STATE OF NORTH CAROLINA
DEPARTMENT OF TRANSPORTATION

Subject: Modification request for Section 404 Nationwide Permits 12 and 14 and Section 401 Water Quality Certification for the construction of the US 401 improvements in Fayetteville, Cumberland County TIP No. U-4405. Debit \$570 from WBS 39049.1.1.

Reference: Section 404 USACE Action ID. SAW-2011-01806, issued December 1, 2017
Section 401 NCDWR Project No. 20171365, issued November 15, 2017

PERMIT DRAWING
SHEET 5 OF 18
REVISED: 2/6/2018

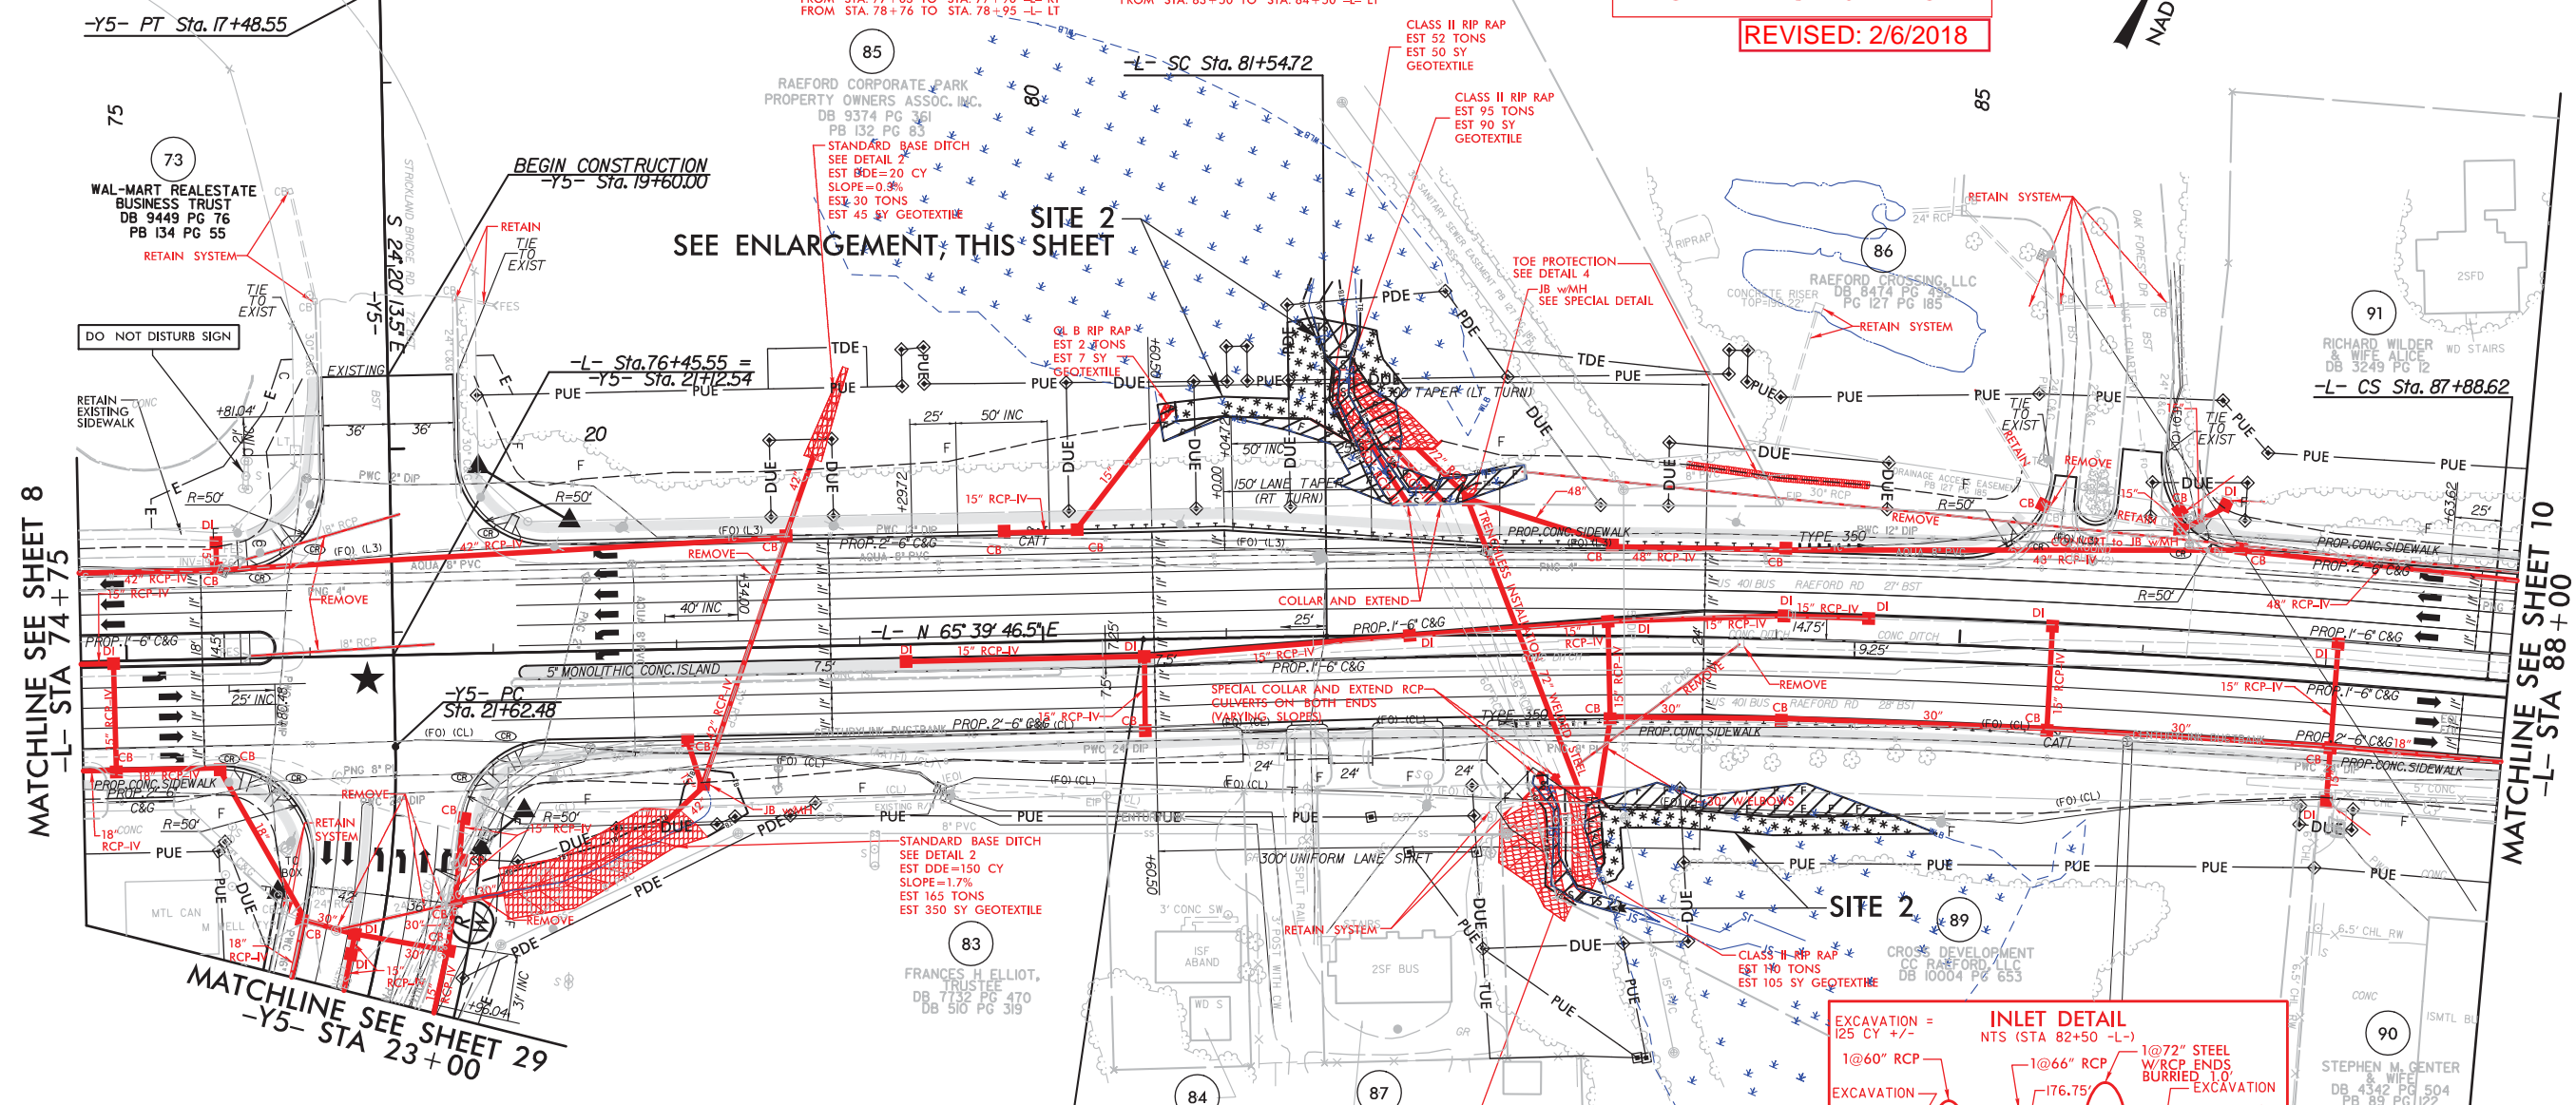
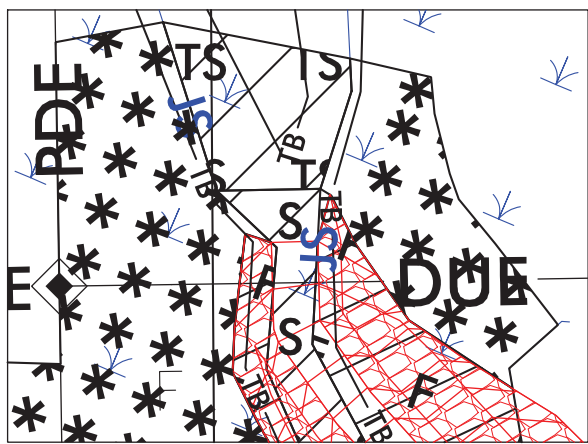
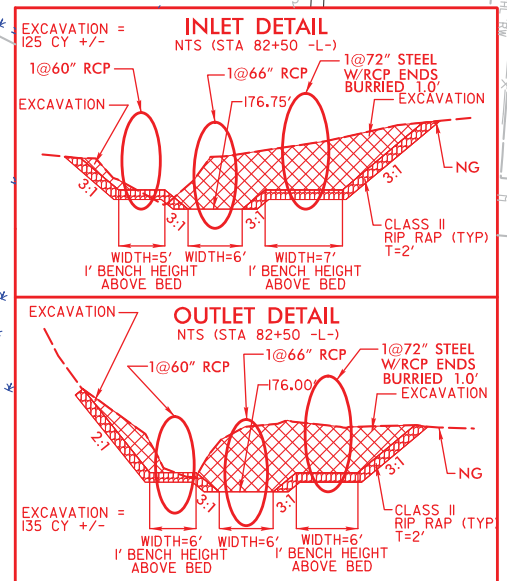
Site 2: An additional 10 feet of temporary stream impacts have been added at the downstream end. The temporary channel impacts and surface water impacts have increased in the summary sheet by 10 feet and 0.01 acre.

PERMIT DRAWING
SHEET 15 OF 18

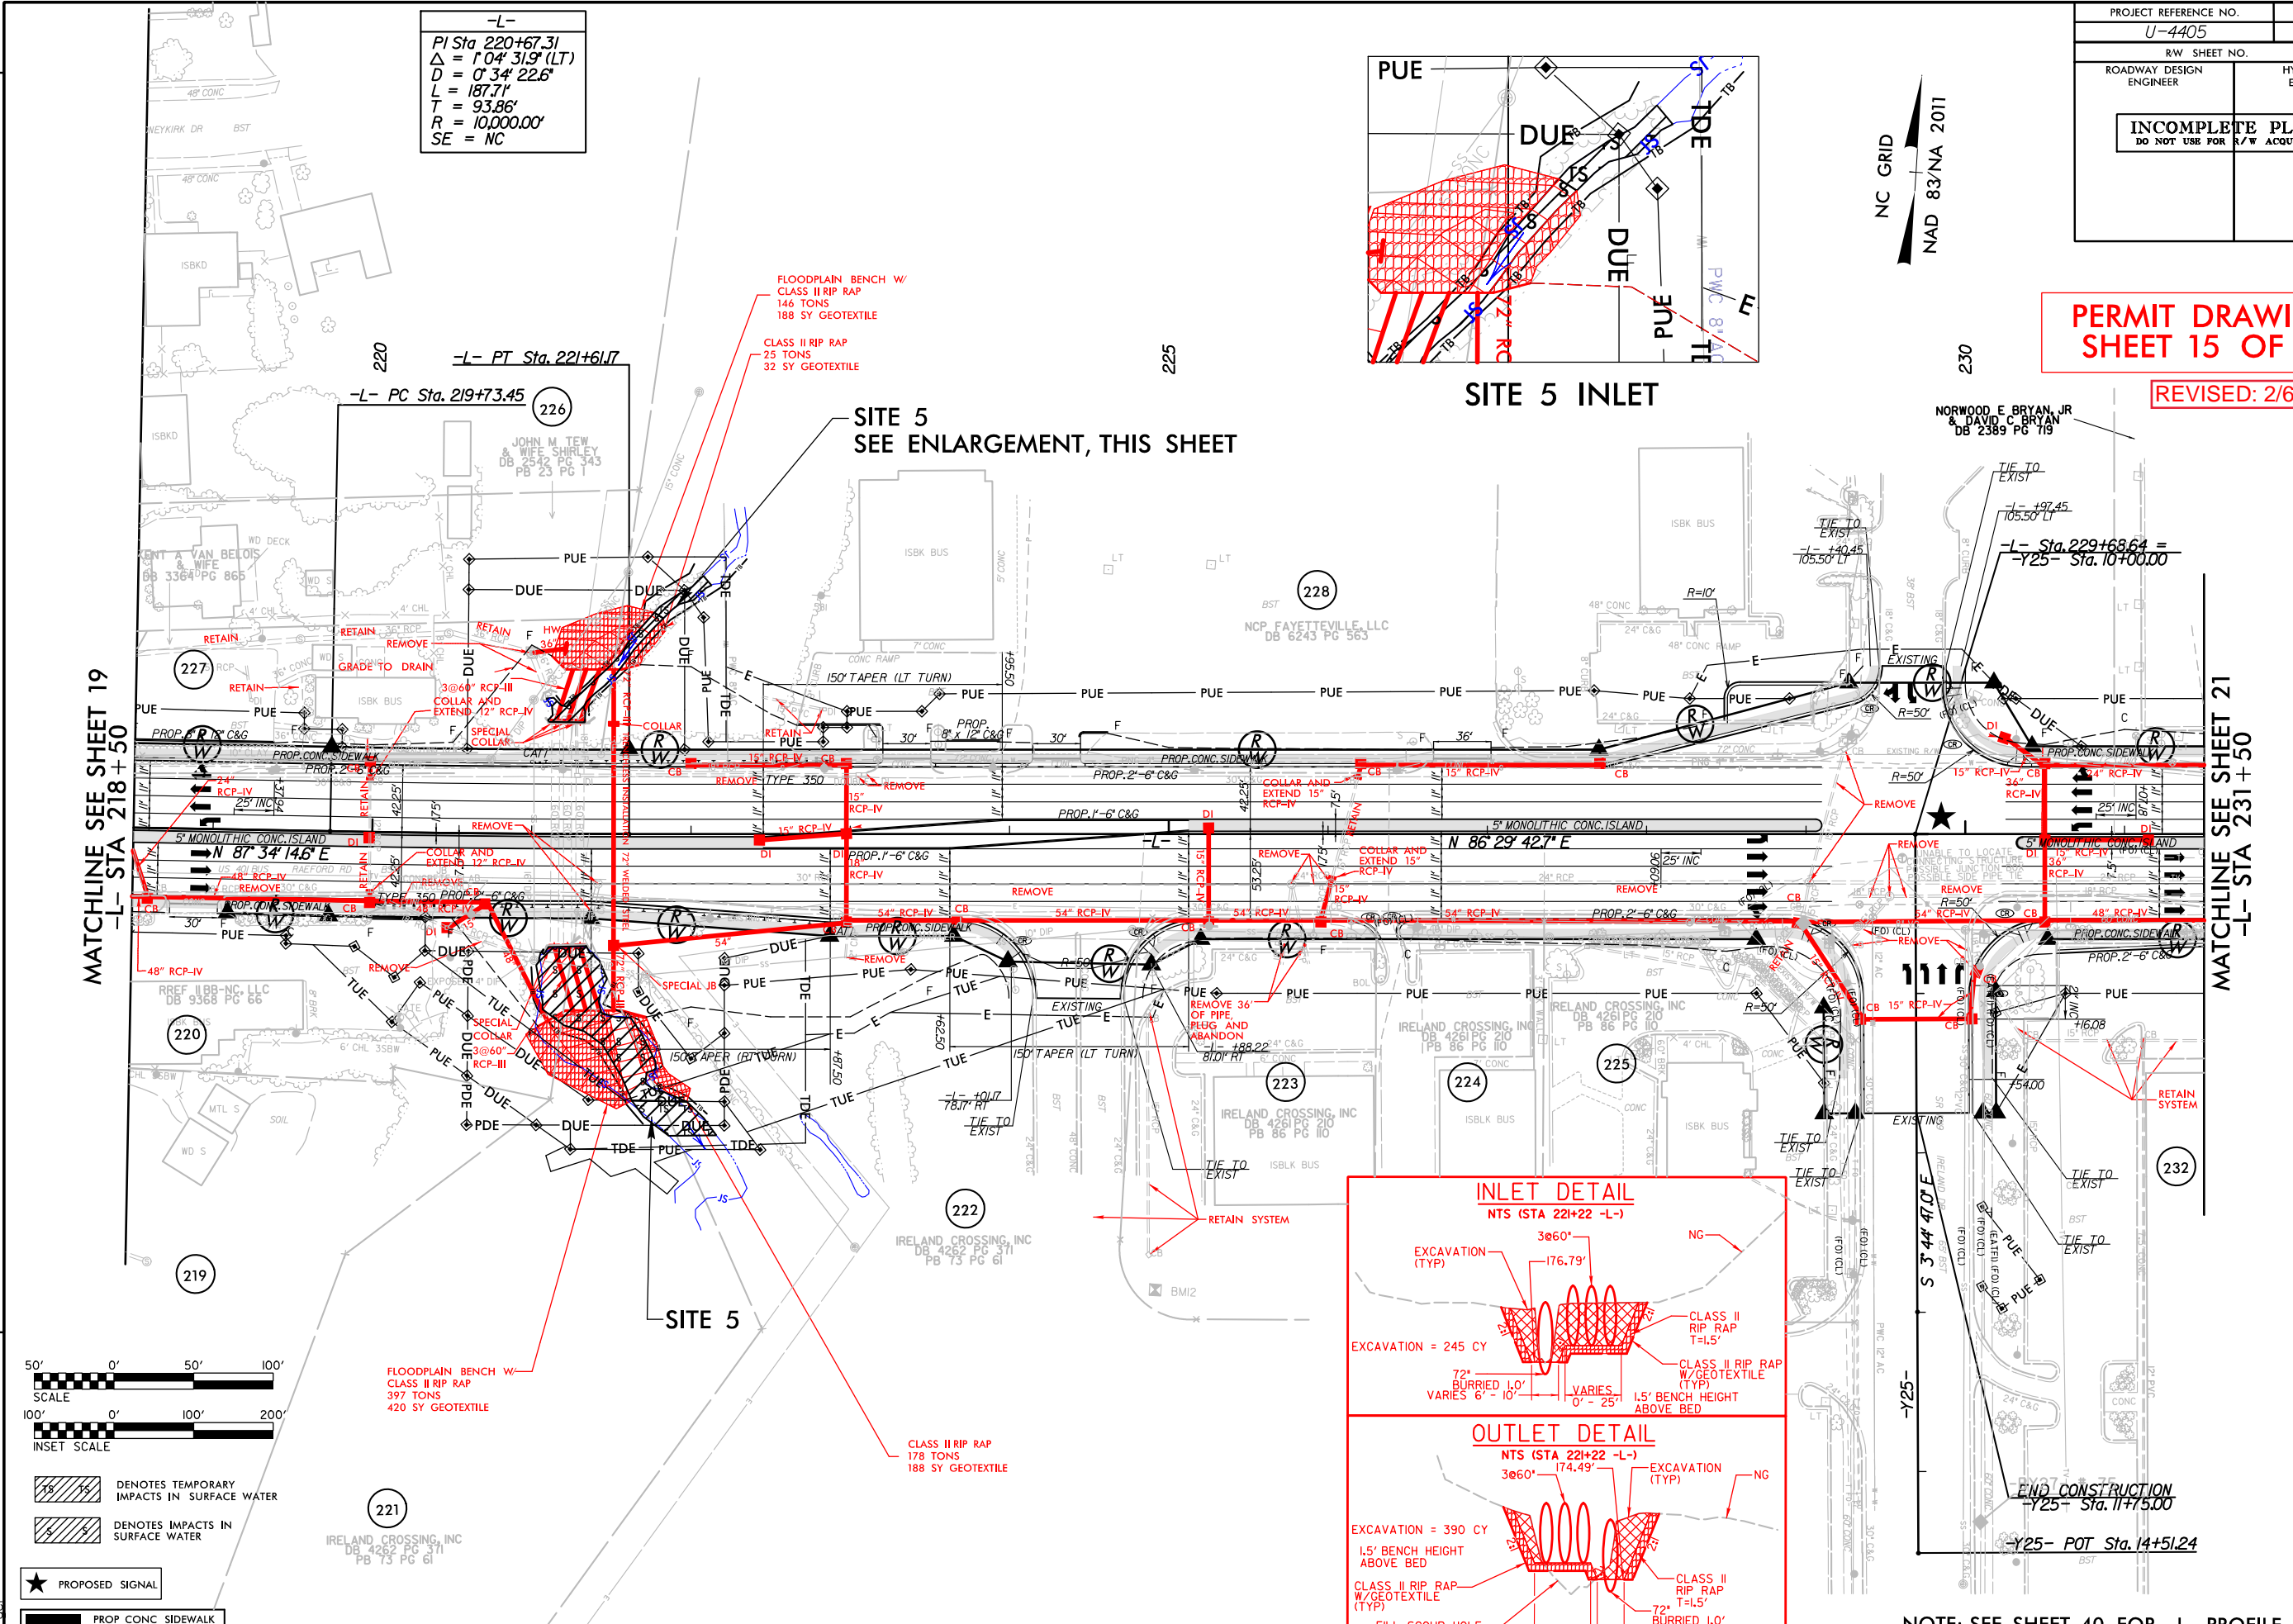
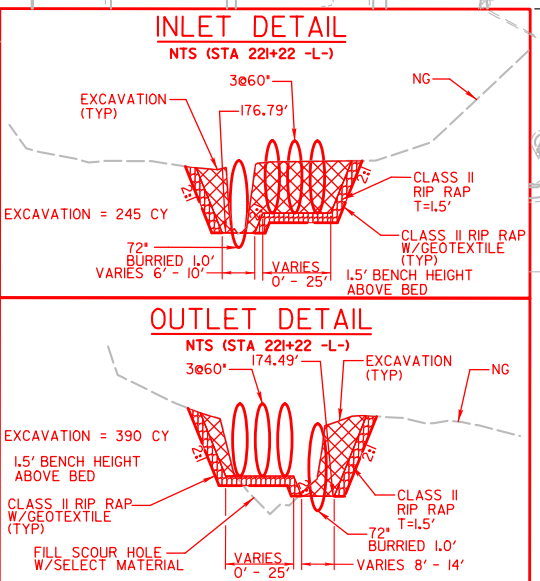
Site 5: The temporary stream impacts were extended on the upstream end (previously stopped just inside the DUE, now extends between the DUE and TDE) and shortened on the downstream end (previously extended to area between DUE and TDE, now stops inside of DUE area). Temporary surface water impacts increased to 0.02 ac.
